AGENDA PLANNING COMMISSION MEETING

October 16, 2025 - 6:00 PM
City Hall Council Chambers

To: Planning Commission
From: Heather Botten
Date: October 8, 2025
Subject: Packet Material for the October 16, 2025 Planning Commission Meeting
Agenda Item: Mister Car Wash Conditional Use Permit
Application Action Deadline: October 24, 2025

LANDSCAPE
PLANTING PLAN

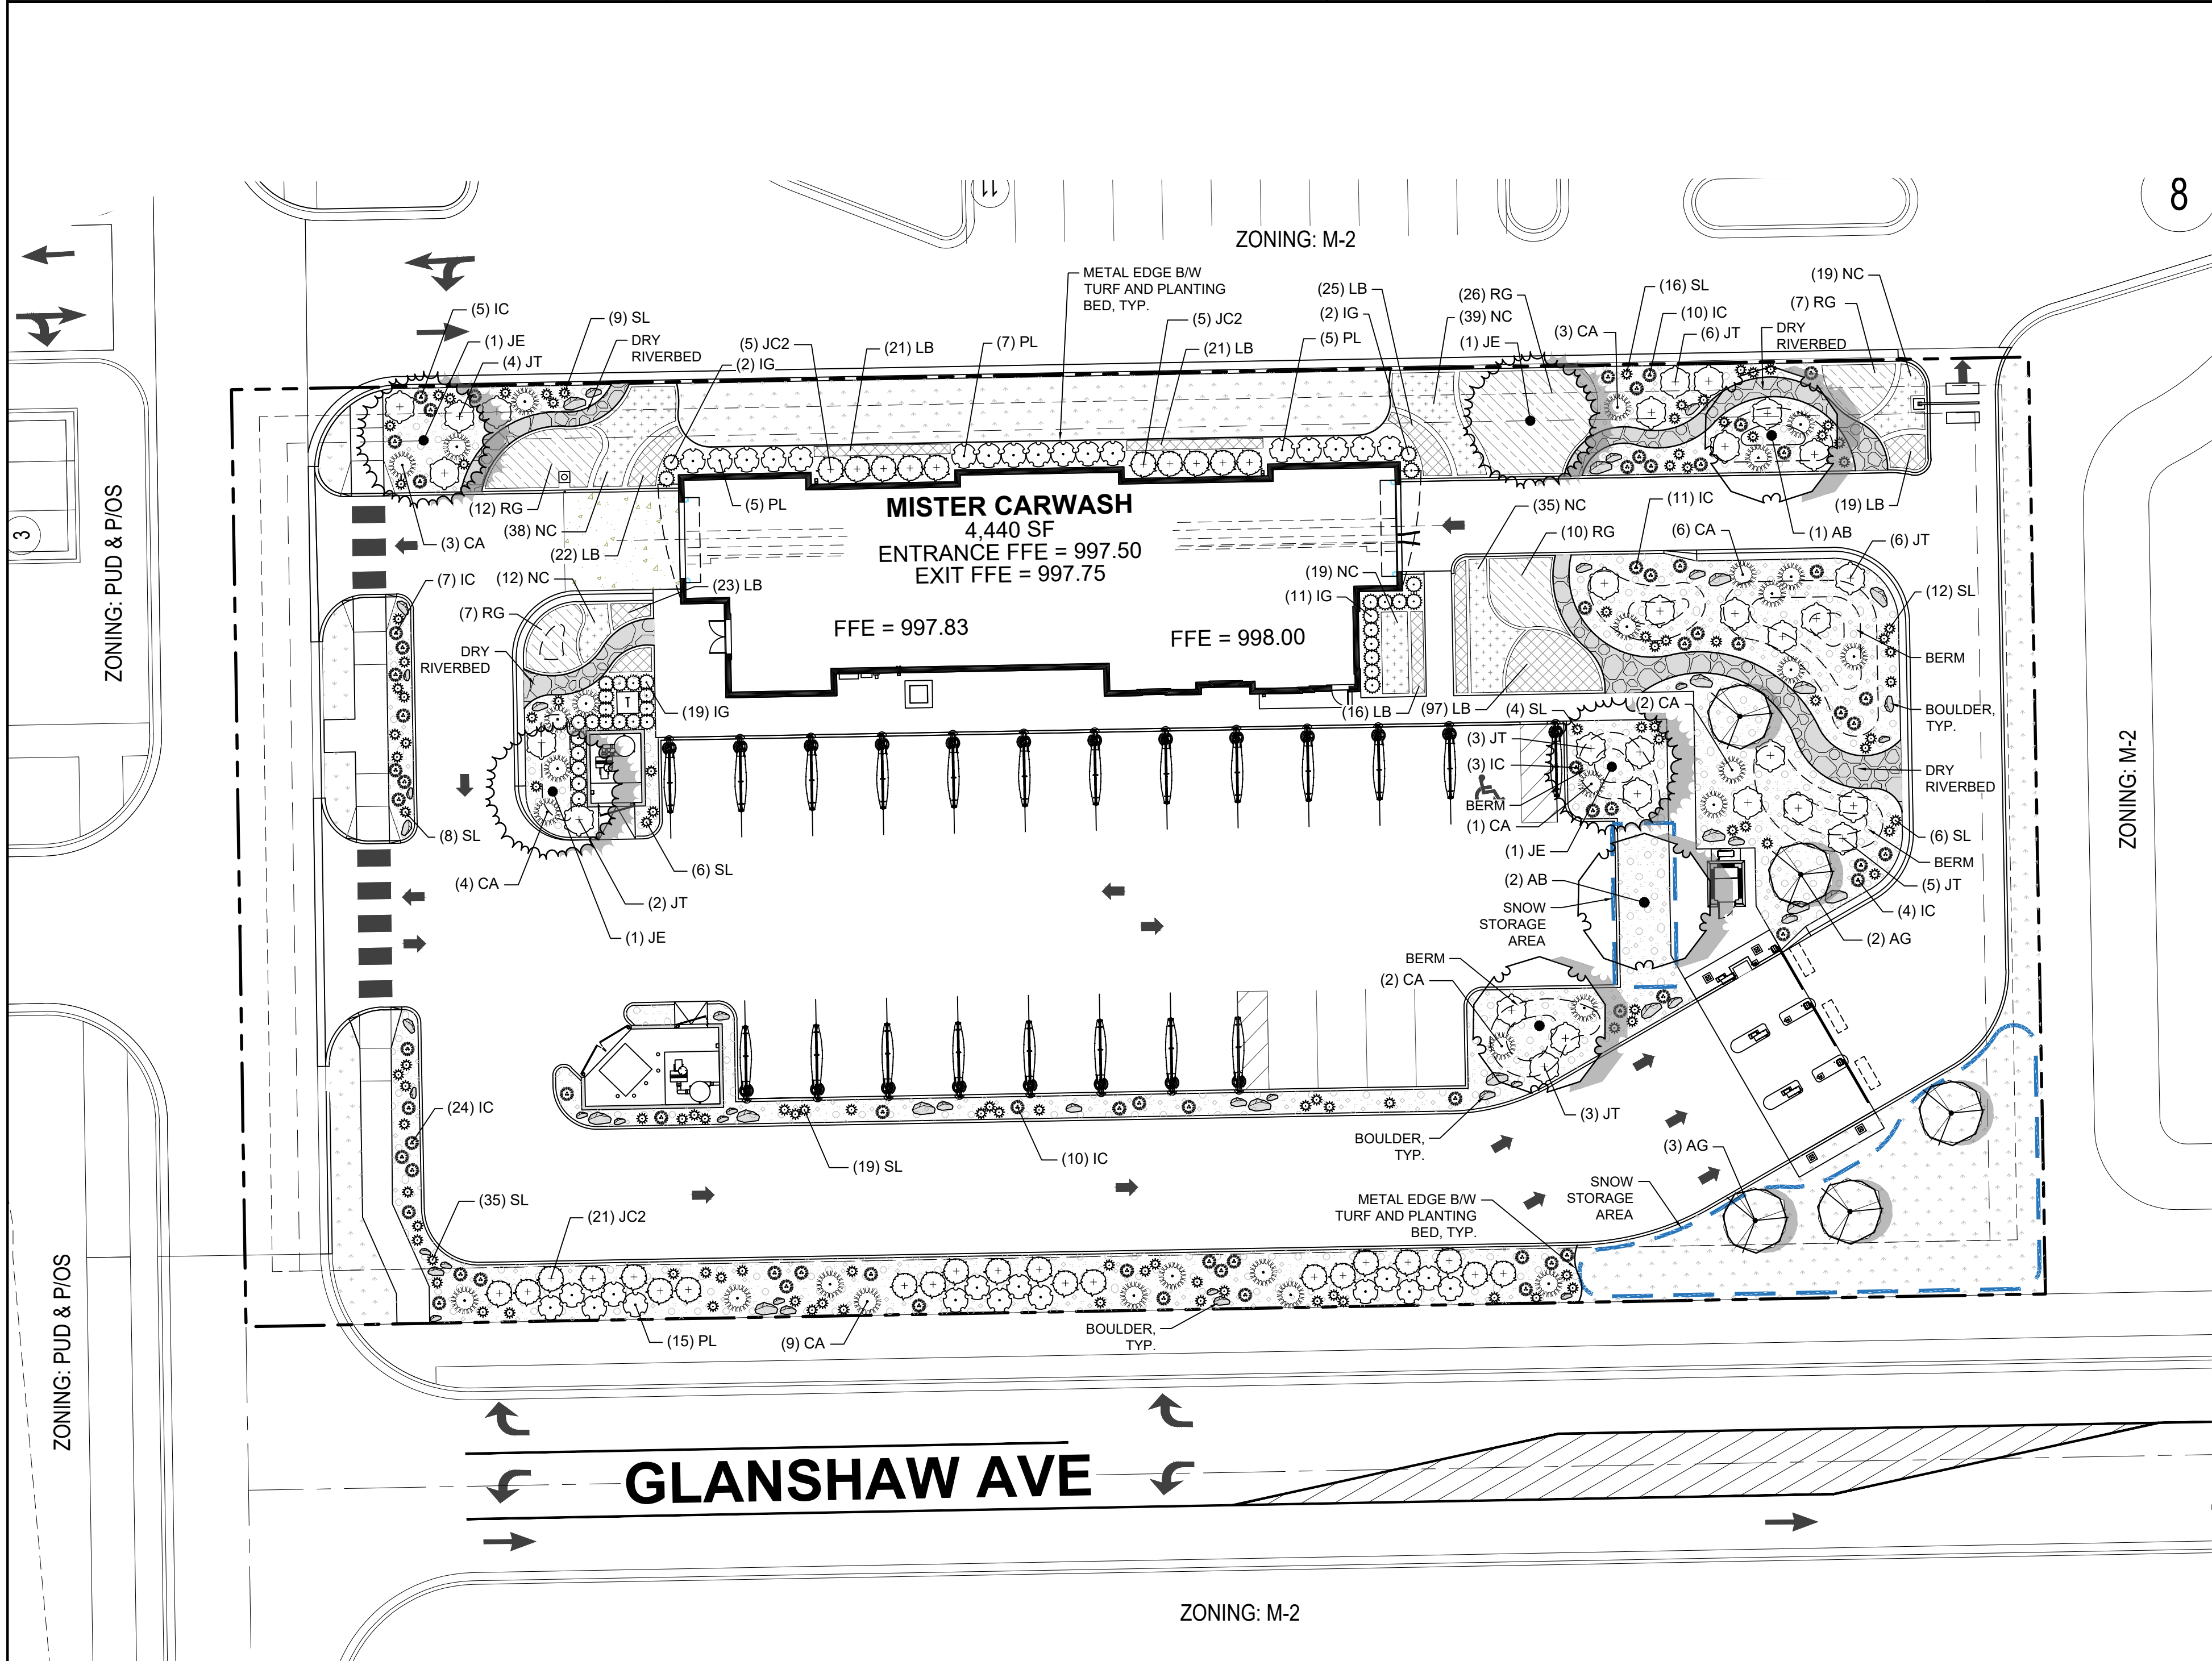
Landscaping. The landscape plan provides a variety of planting around the site. A row of trees is required along the west side of the pond to minimize noise and headlights shining onto Glacier Way and the residential units east of Glacier Way. The City Forester reviewed the proposed

landscape plan and commented that Item C (D): Tree Planting should include a note about B&B tree planting that specifies the removal of twine and burlap from the top half of the root ball; as well as specifying that the root flare is to be exposed and set at or slightly above grade. The tree planting detail includes this information but it should be included in the specifications.

The landscape plan must be updated to reflect these changes prior to City Council consideration of the CUP. Including the landscape modifications, the landscape plan will be considered approved. Plantings on the site must adhere to the plan and provide a as-built landscape plan prior to inspection of the installed landscaping. An escrow for the landscape materials and installation amount will be collected with the building permit.

4. Prior to consideration by the City Council, the landscape plan must be revised to show plantings on the west side of the stormwater basin and adjust the text on the plans as noted by the City Forester. A security for landscaping must be submitted with the building permit and an as-built plan of the landscaping submitted prior to inspection.
